**Subject: Final Feasibility Study for the Munitions Washout Facility (SEAD-4),  
Seneca Army Depot Activity**

**Subject: Final Feasibility Study for the Munitions Washout Facility (SEAD-4),  
Seneca Army Depot Activity  
EPA Site ID: NY0213820830 - NY Site ID: 8-50-006;**

**FINAL  
FEASIBILITY STUDY  
AT THE MUNITIONS WASHOUT FACILITY (SEAD-4)**

O:\Seneca\id-4\Sead4-fs.apr

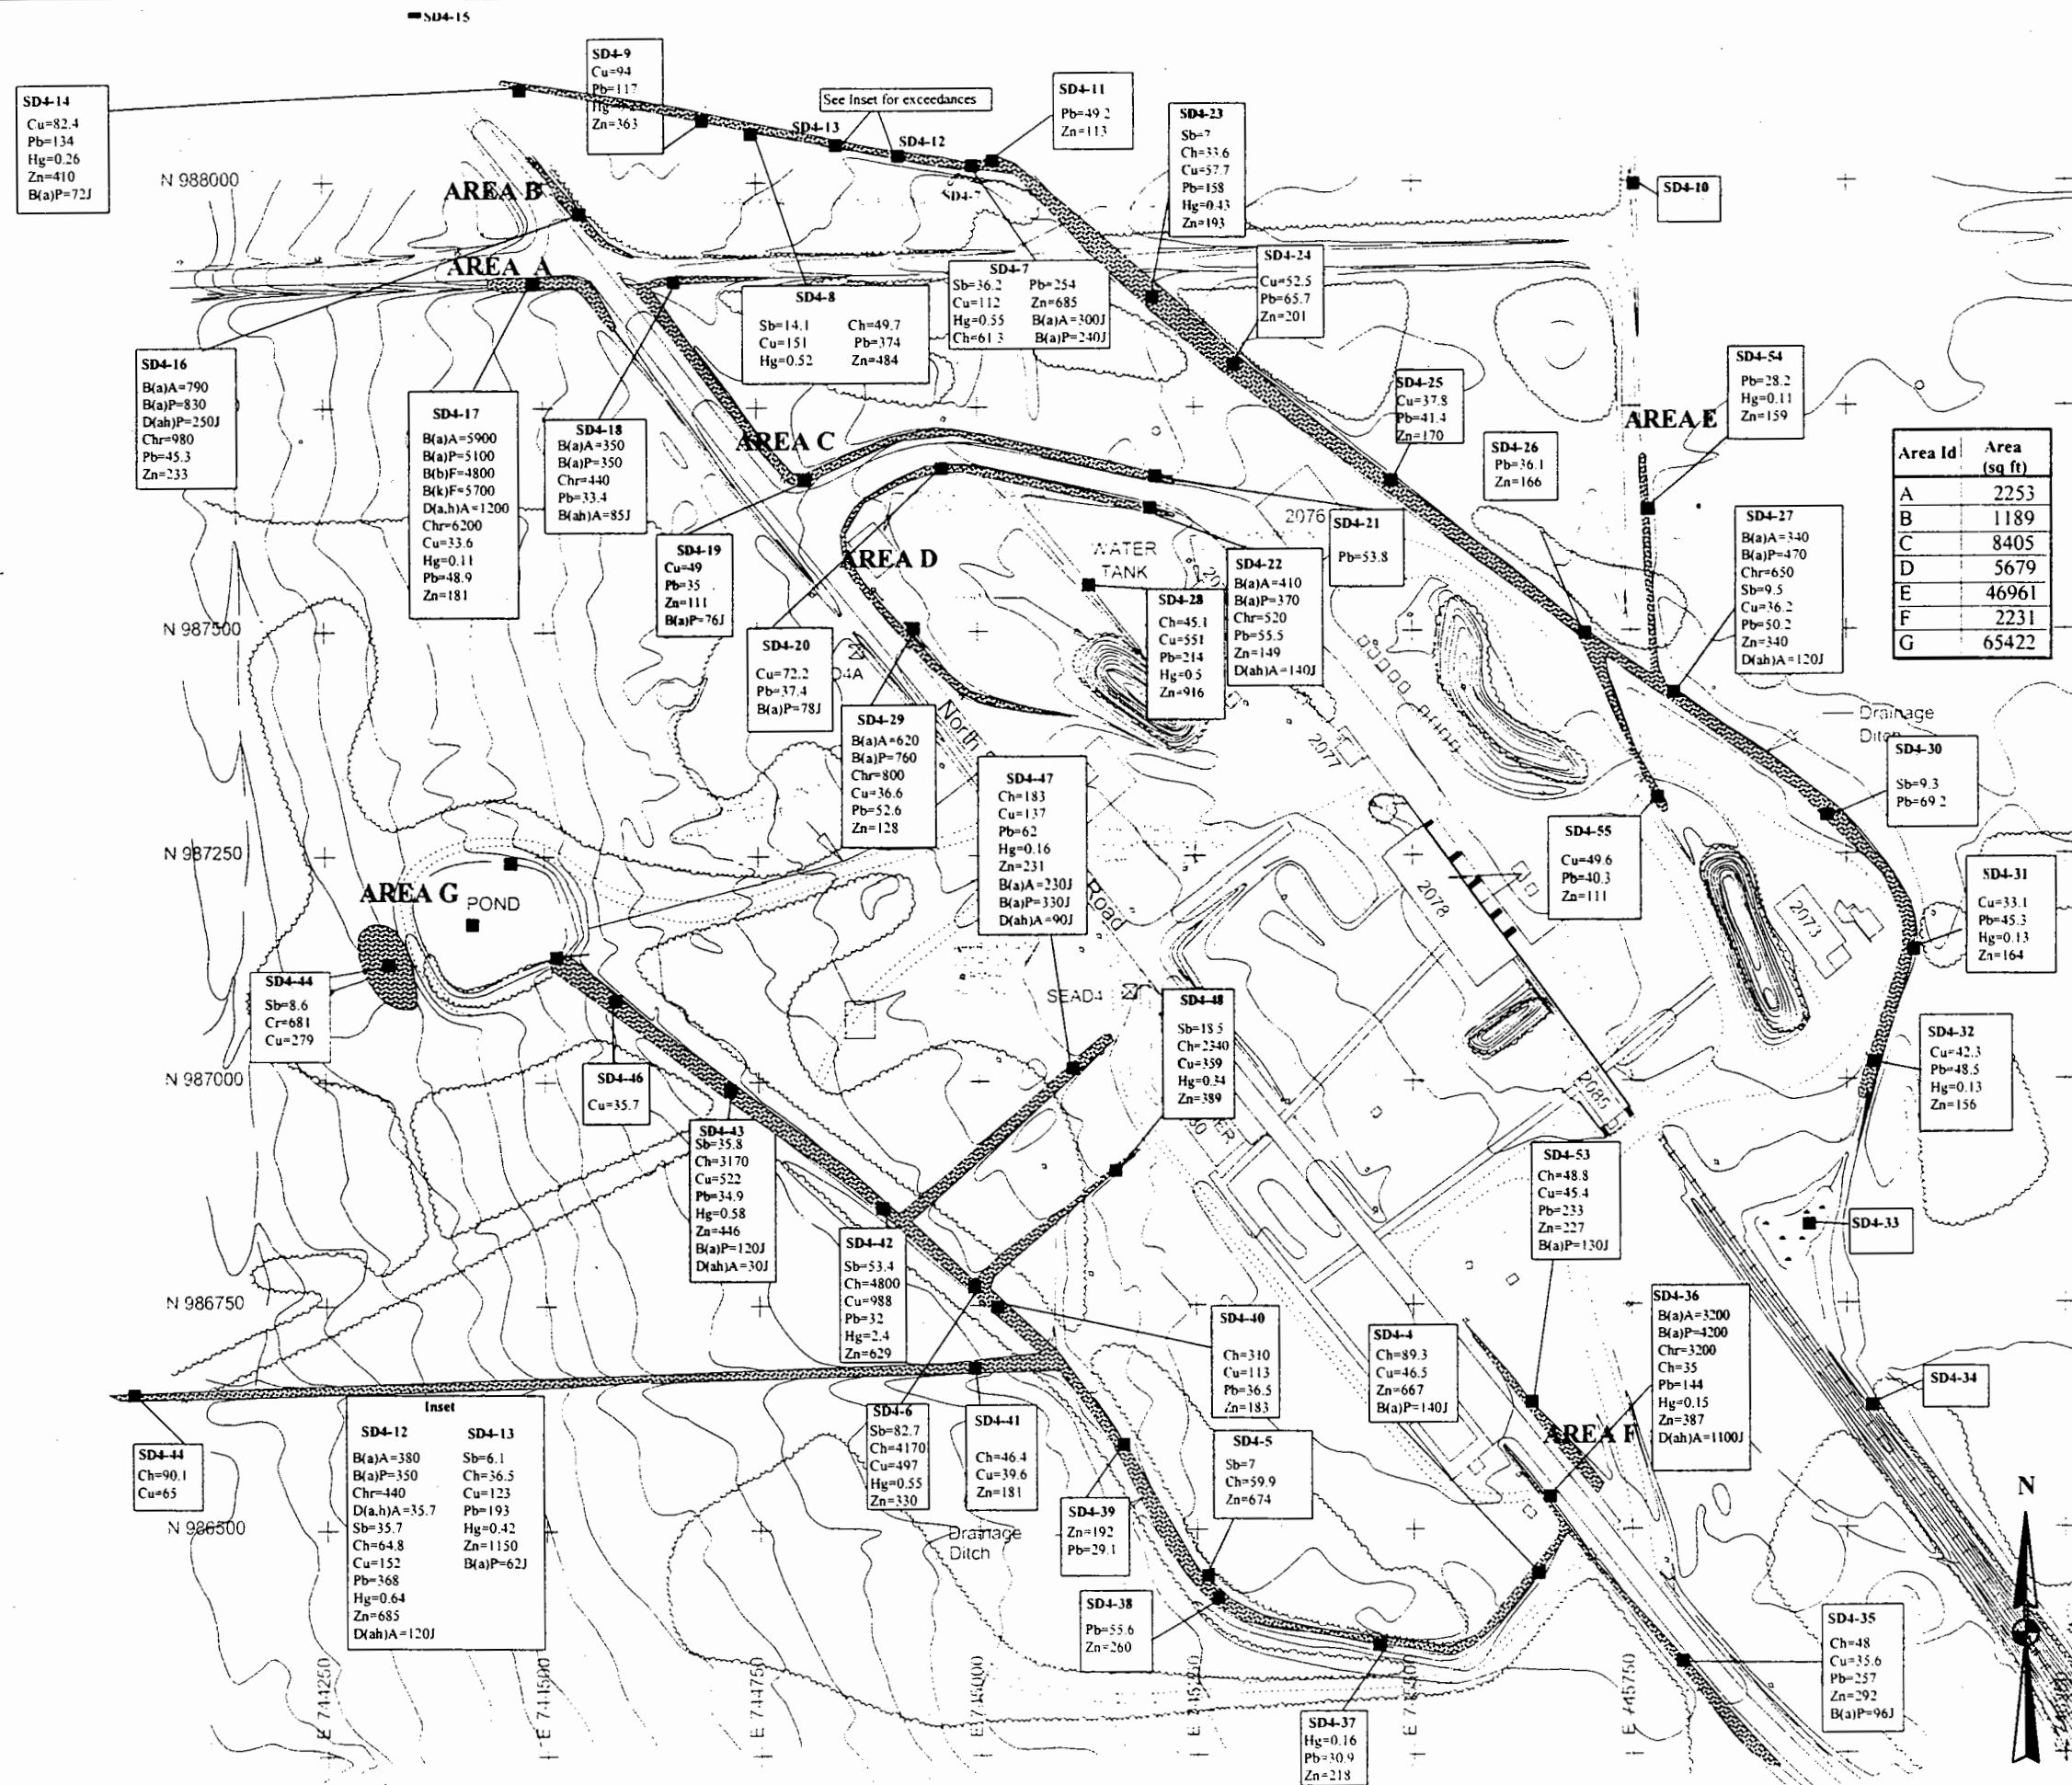
**Comment 12:** Figures 2-10 through 2-12: The tables in the legend of each figure are difficult to read. Please make them legible.
